ATOMIC POWER COMPANY •

August 22, 1985
MN-85-153

Subject: Maine Yankee Control Room Design Review

Per your request, attached please find the HED resolution package. This package was previously sent to you informally on August 8, 1985.

PROPOSED PZR PANEL I & C LOCATIONS

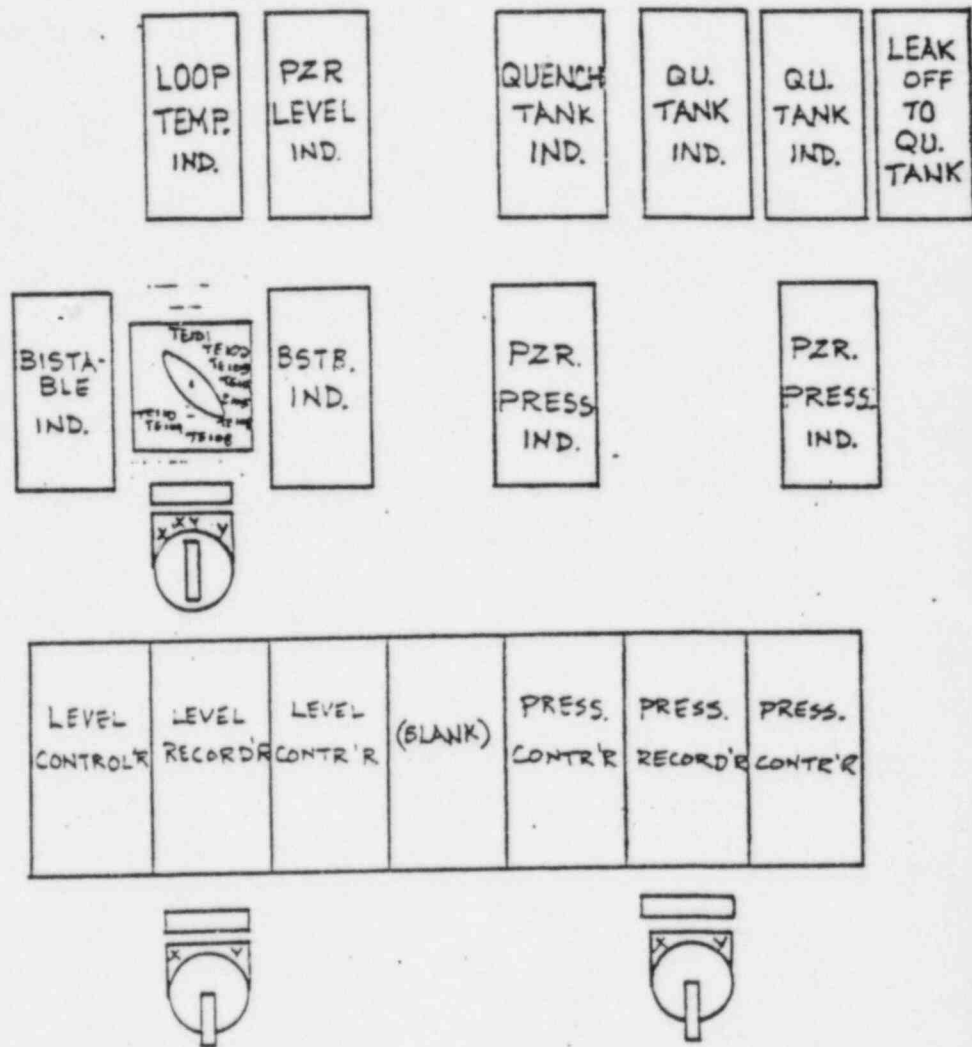
* TO BE RELOCATED

Project Description/Discussion: CVCS and Loop Panel indications are to be relocated for better utilization of the instruments in order that consistent, orderly system action can be achieved. This project has been designed to minimize the number of cut-outs and alterations on the MCB. See attached notes and drawing for new locations of instruments and associated mimics.

TITLE: Correct Input Signals For SIAS Annunciator

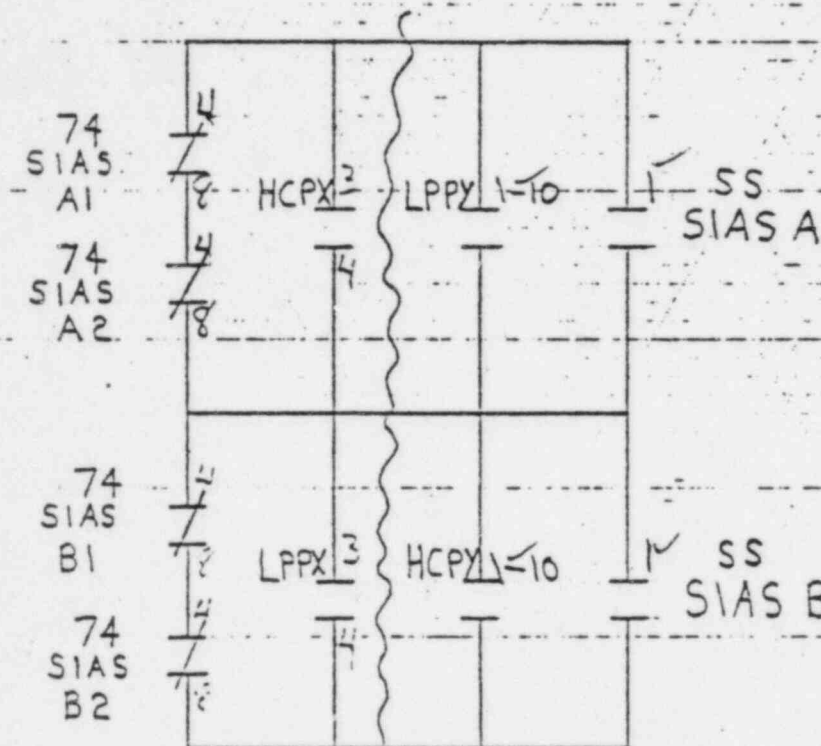
EXISTING CIRCUIT ← → NEW CIRCUITRY NEEDED
TO PROVIDE CLOSE CONTACTS
UPON ACTIVATION OF SIAS
THAT WILL BYPASS THE LOSS
OF CONTROL POWER
ANNUNCIATION.

ANNUNCIATOR CIRCUIT FOR LOSS OF CONTROL POWER

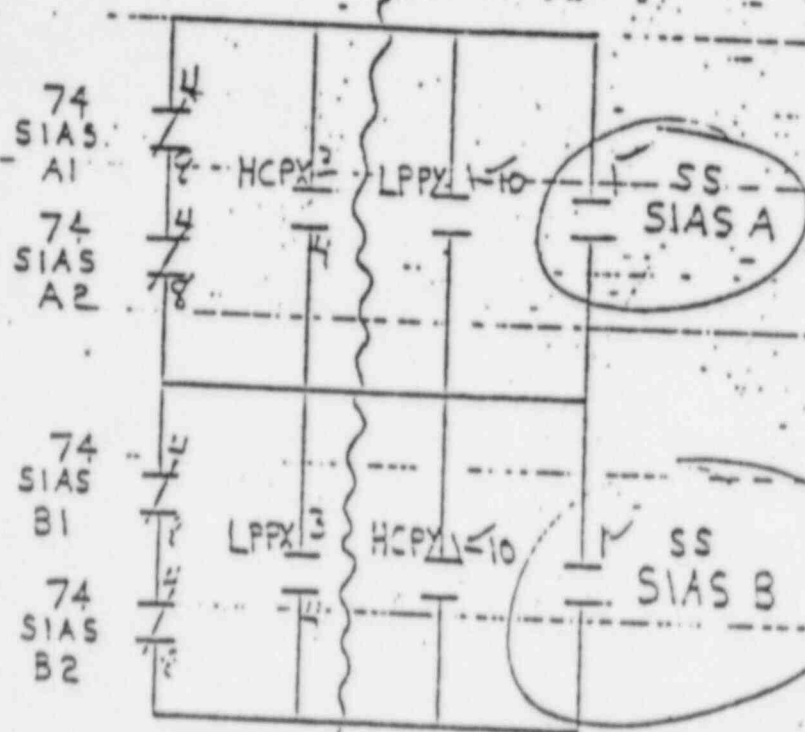
EXISTING CIRCUIT \leftarrow \rightarrow NEW CIRCUITRY NEEDED
TO PROVIDE CLOSE CONTACTS
UPON ACTIVATION OF SIAS
THAT WILL BYPASS THE LOSS
OF CONTROL POWER
ANNUNCIATION.

ANNUNCIATOR CIRCUIT FOR LOSS OF CONTROL POWER

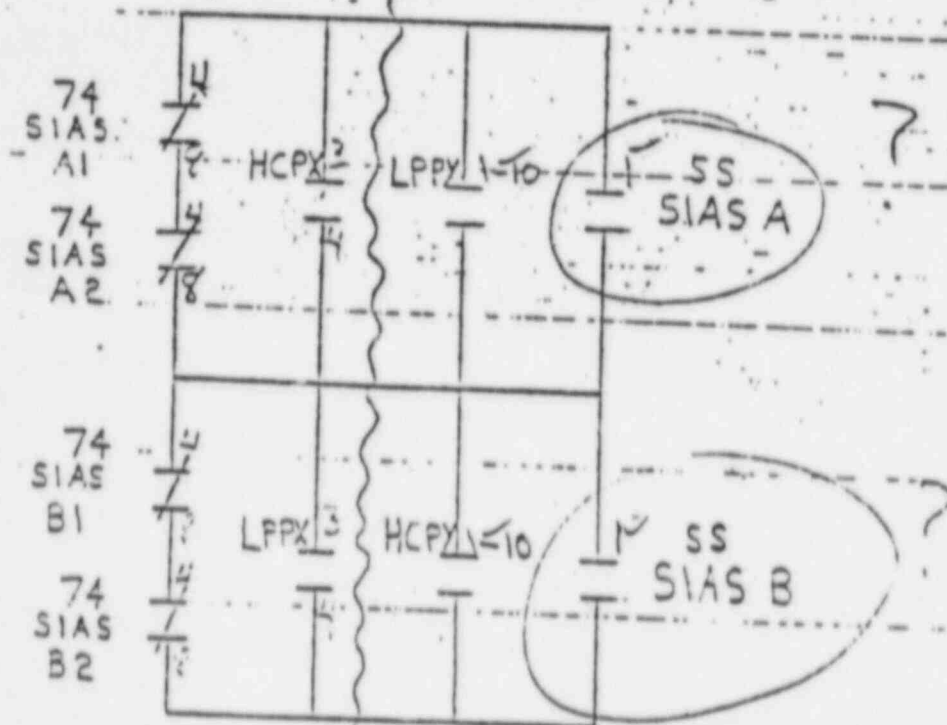
EXISTING CIRCUIT \leftarrow \rightarrow NEW CIRCUITRY NEEDED
TO PROVIDE CLOSE CONTACTS
UPON ACTIVATION OF SIAS
THAT WILL BYPASS THE LOSS
OF CONTROL POWER
ANNUNCIATION.

Sketch #5

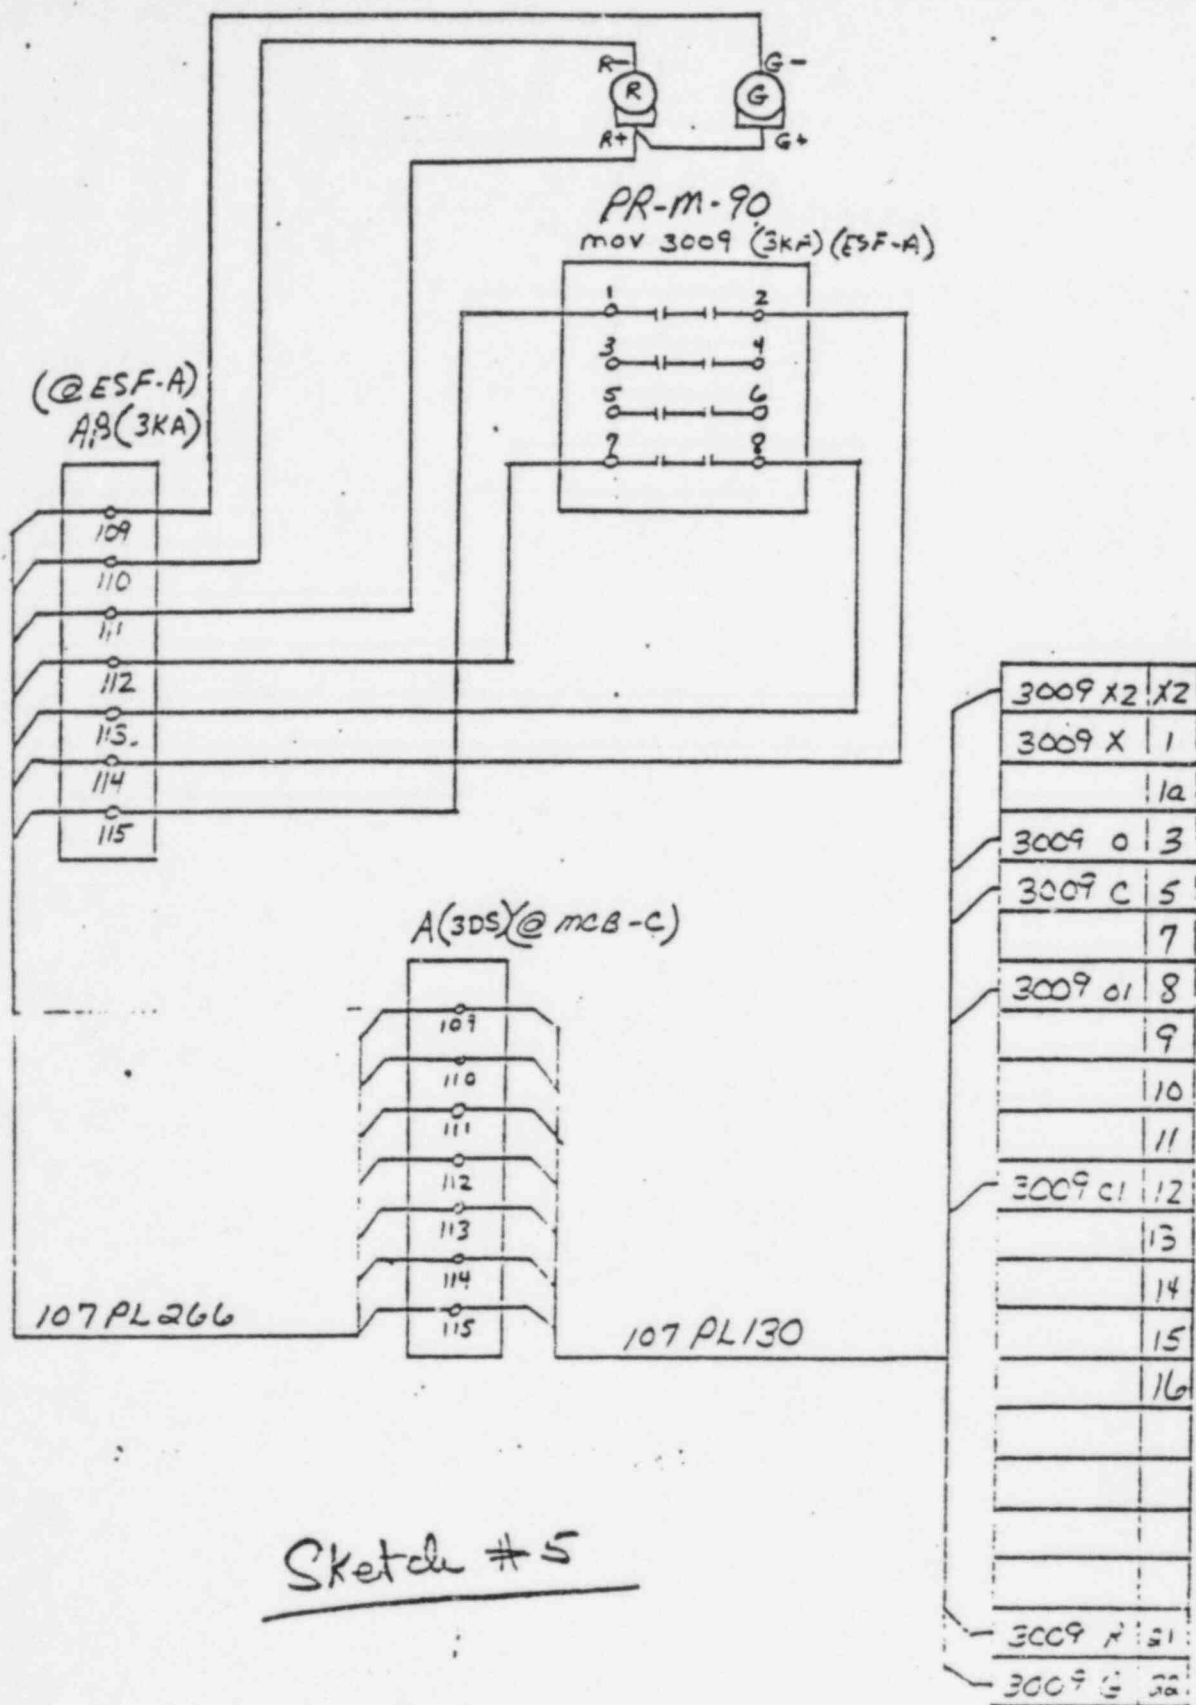
- 14.1 Sketches 1 through 4 are present plant configuration for PR-M-90 (MOV-3009), RC-M-56 (MOV 3007), PR-M-89 (MOV 3008), and RC-M-54 (MOV-3006).
- 14.2 Sketches 5 through 8 are proposed plant configuration for PR-M-90 (MOV-3009), RC-M-56 (MOV-3007), PR-M-89 (MOV-3008), and RC-M-54 (MOV-3006).
- 14.3 Sketch #9 shows dimensions and configuration of Electros witch to be used as replacement.

SKETCH # 1

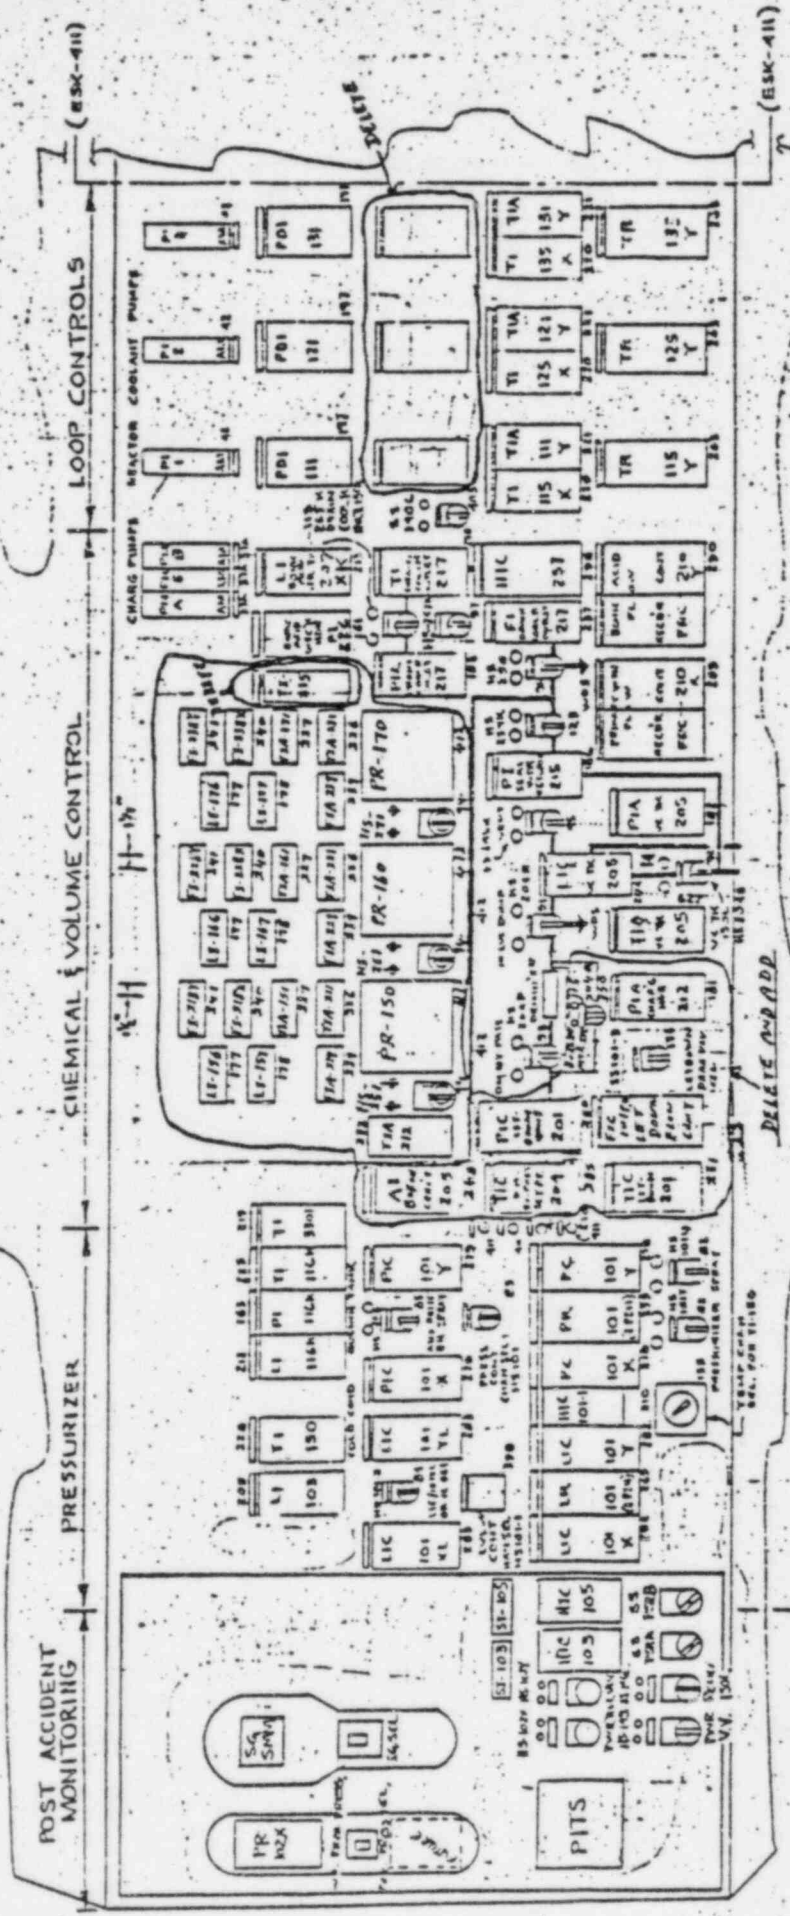
SERIAL NO.	REASON FOR CHANGE	INSTRUMENT BEING RELOCATED	INSTRUMENT SYSTEM	NEW LOCATION OF INST. IN PLACE OF PRESENTLY OCCUPIED BY/ NEW CIRCUIT	REF. SKETCH NO. FOR NEW LOCATION	DESIGN CHANGE	NOTES
11	HED 564	AI-203	Boron Concentration	TIC-201	Sketch-1 (ESK-4G)	NNS	
12	Obvious	PIC-201	Letdown Press	FI-202	Sketch-1 (ESK-4G)	NNS	
13	Obvious	TIC-204	Letdown Temp Bypass	AI-203	Sketch-1 (ESK-4G)	NNS	
14	Obvious	SS-101-3	Letdown Drag Valve SEL LD-A-9.10	PIA-212	Sketch-1 (ESK-4G)	NNS	
15	Obvious	IIS-201K	Letdown Line Stop LD-M-2	IIS204Q	Sketch-2 (ESK-4C)	NNS	
16	Obvious	IIS-242	Letdown Temp. Trip LD-T-5	Below IIS204Q	Sketch-2 (ESK-4C)	NNS	
17	Obvious	IIS-204Q	Boronmeter ISOL	Above PIA in Deminrz Loop New PNL Cut	Sketch-1 (ESK-4G)	NNS	CPA shows its new loc. above switch 01/212 on ESK. 4C. CPA 40-84 has been superceded by FCB per HF steering Com.
18	Per FCB	FIC-216	Fill HDR Flow CH-F-70	On RT. Side of PIC-211	Sketch-2 (ESK-4C)	IE

SKETCH # 2

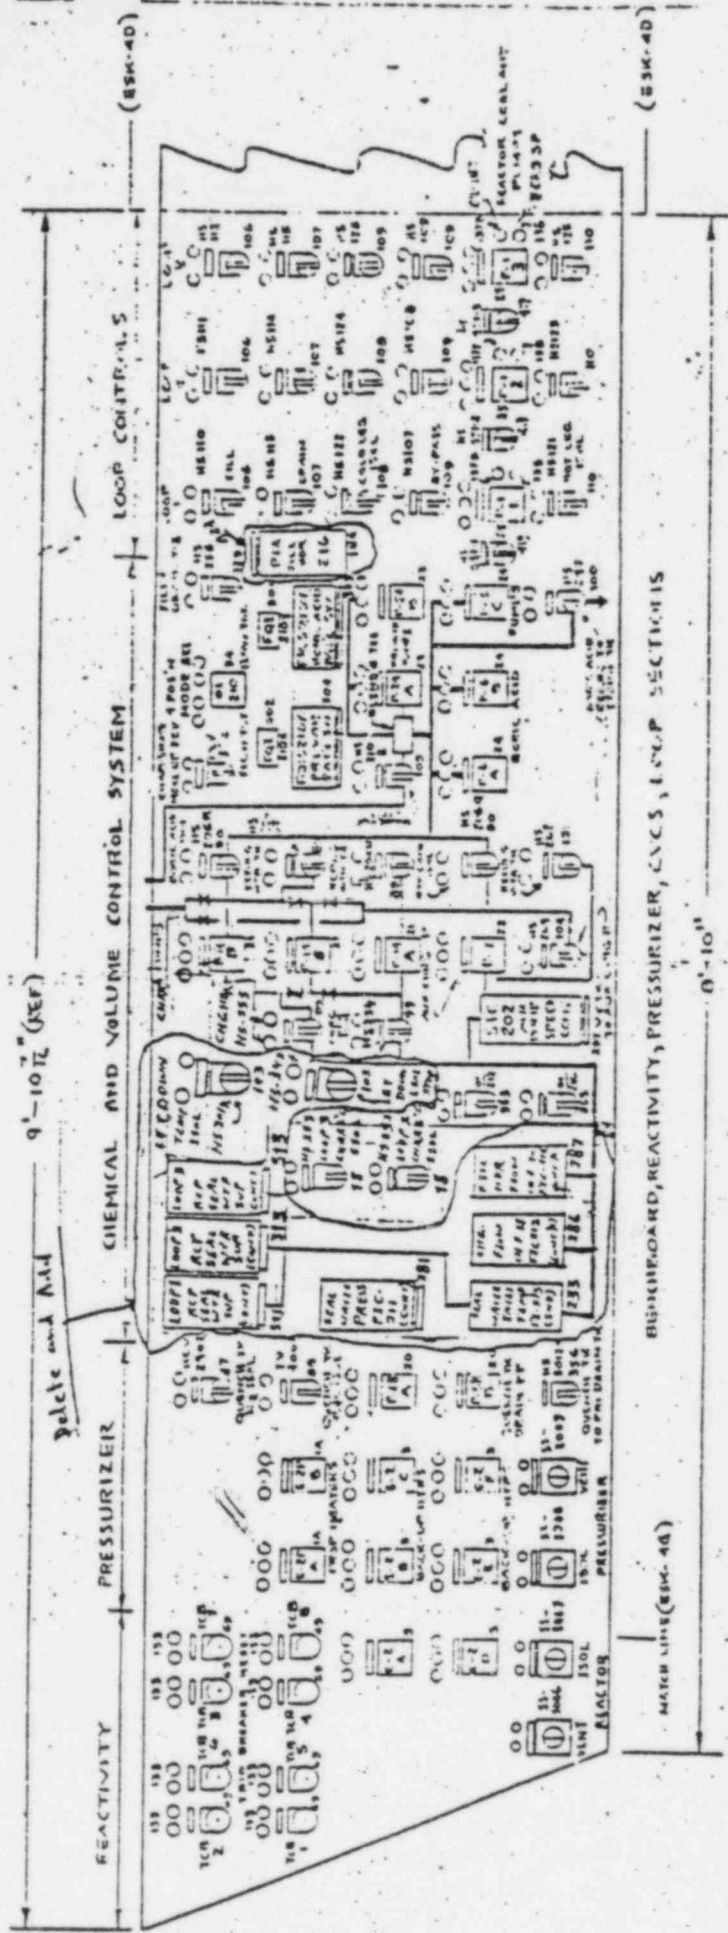
SERIAL NO.	REASON FOR CHANGE	INSTRUMENT BEING RELOCATED	INSTRUMENT SYSTEM	NEW LOCATION OF INST. IN PLACE OF PRESENTLY OCCUPIED BY/ NEW CIRCUIT	REF. SKETCH NO. FOR NEW LOCATION	DESIGN CHANGE	NOTES
1	HED 71	FIC-218Y	Seal Water	HIC-101	Sketch-2 (ESK-4C)	NNS	Previous Tag # PDC-151. Tag changed to FIC-218Y per PDCR 25-73.
2	HED 71	FIC-228Y	Seal Water	SS-101-3	Sketch-2 (ESK-4C)	NNS	Previous Tag # PDC-161. Tag changed to FIC-228Y per PDCR 25-73
3	HED 71	FIC-238Y	Seal Water	On Rt. Side of SS-101-3 New PNL Cut	Sketch-2 (ESK-4C)	NNS	Previous Tag # PDC-171. Tag changed to FIC-238Y per PDCR 25-73.
4	HED 97	(HIC-101)	Let Down Flow Control	PIC-201	Sketch-1 (ESK-4G)	NNS	LY-101w HIC-101 and FI-202 are being replaced by FIC-101 P,Q.
5	HED 97	(FI-202)	Let Down Flow Indicator	PIC-201	Sketch-1 (ESK-4G)	NNS	LY-101w HIC-101 and FI-202 are being replaced by FIC-101 P,Q.
6	HED 559	TI-215	Seal Water Inlet Temp	On LT. Side of FIC-212	Sketch-2 (ESK-4C)	NNS

SKETCH #3

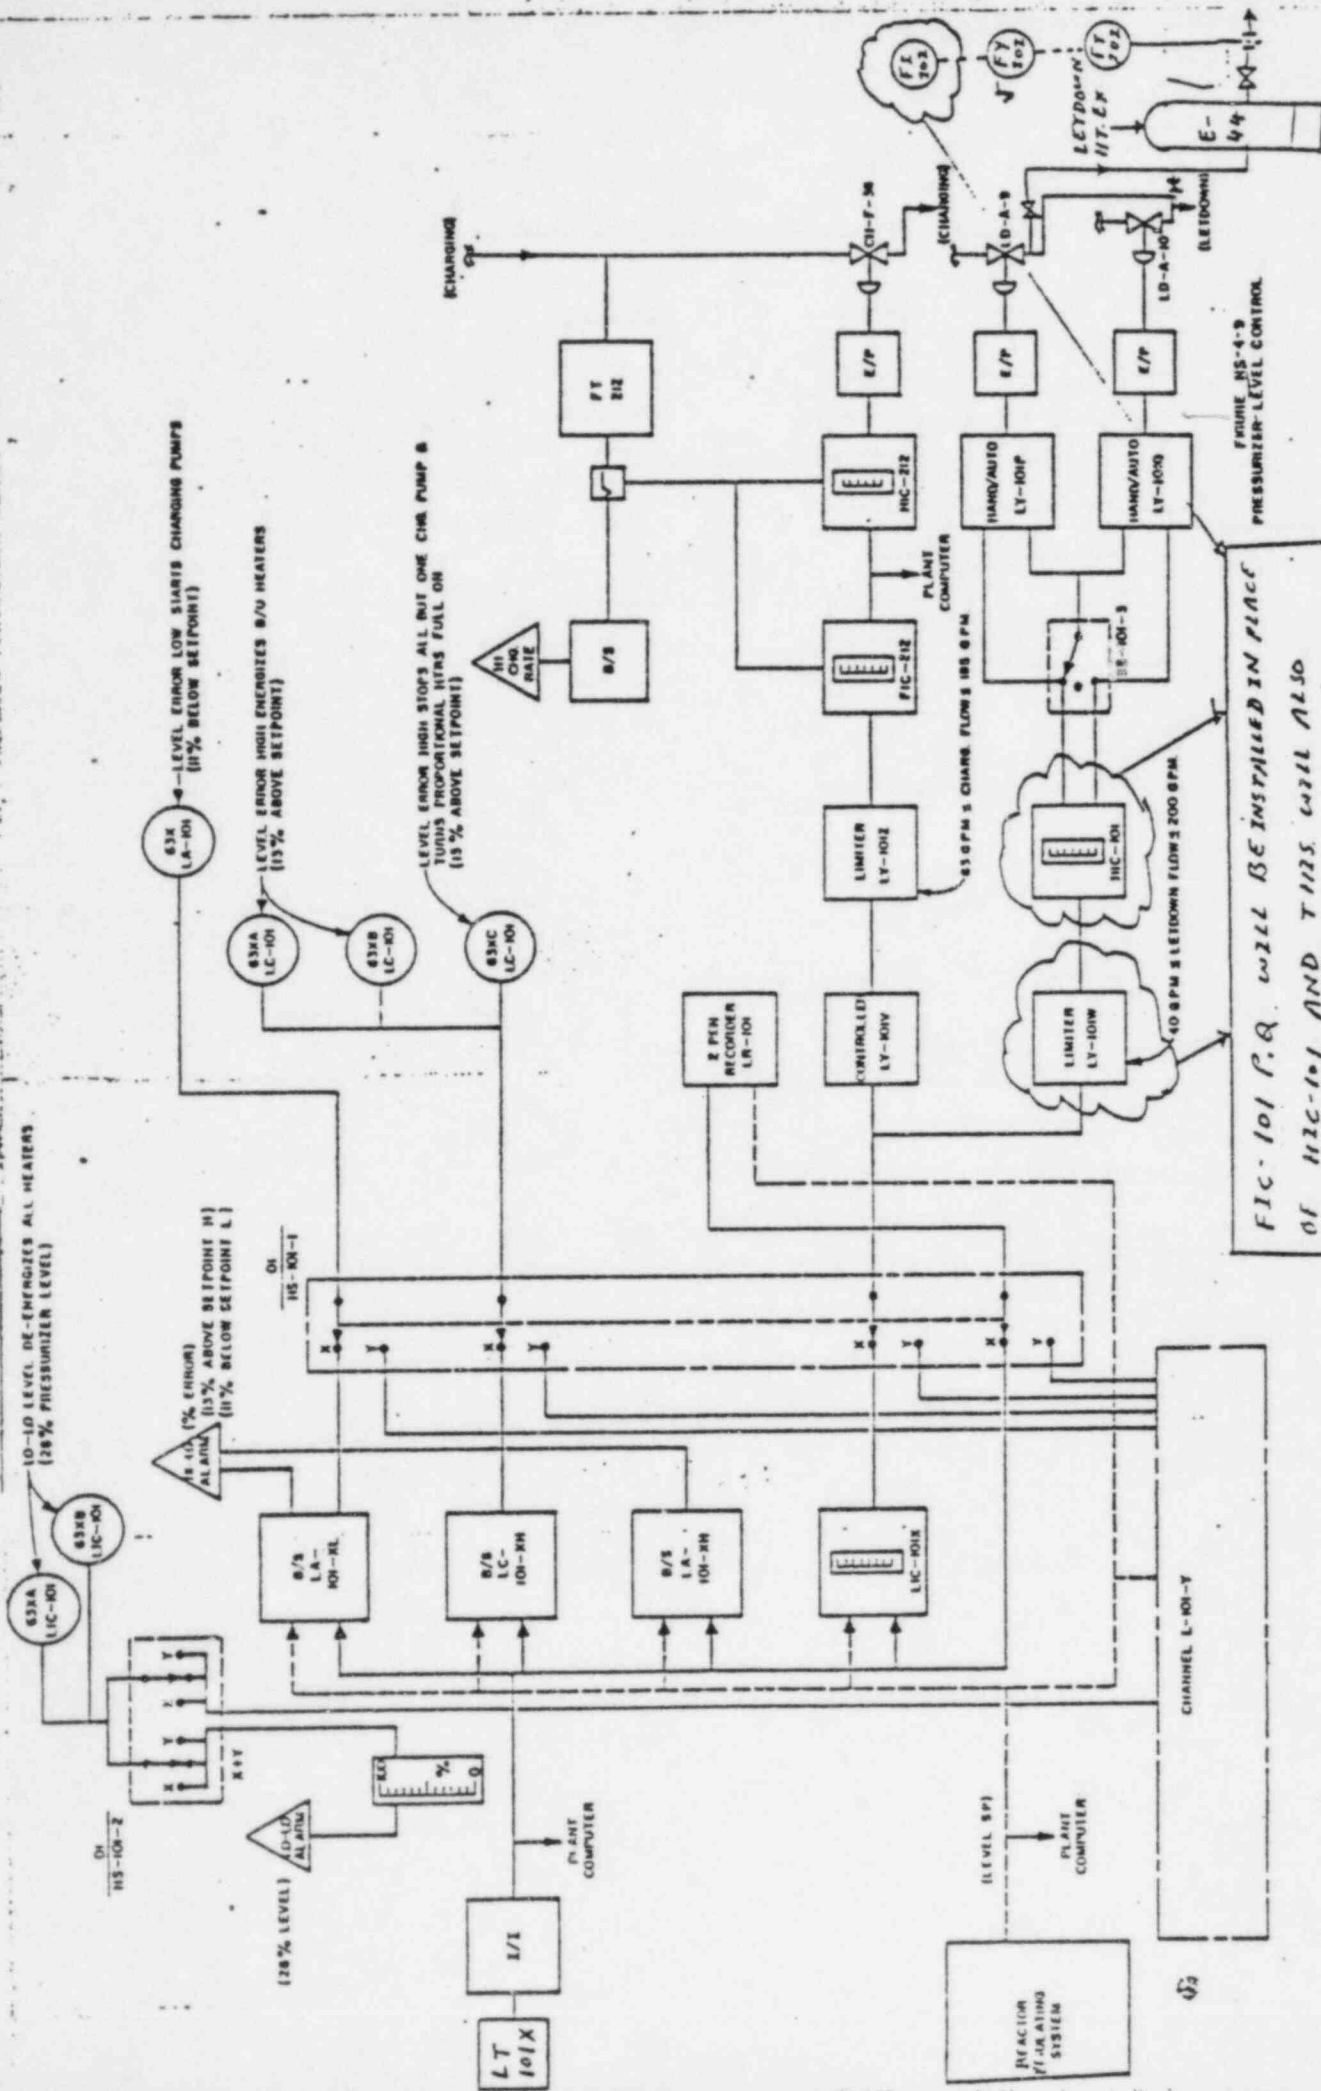
FIG-101 P.Q. will BE INSTALLED IN PLACE OF H2C-101 AND THIS will ALSO INDICATE FLOW AND ELIMINATE F2-202 AND LY-1010.
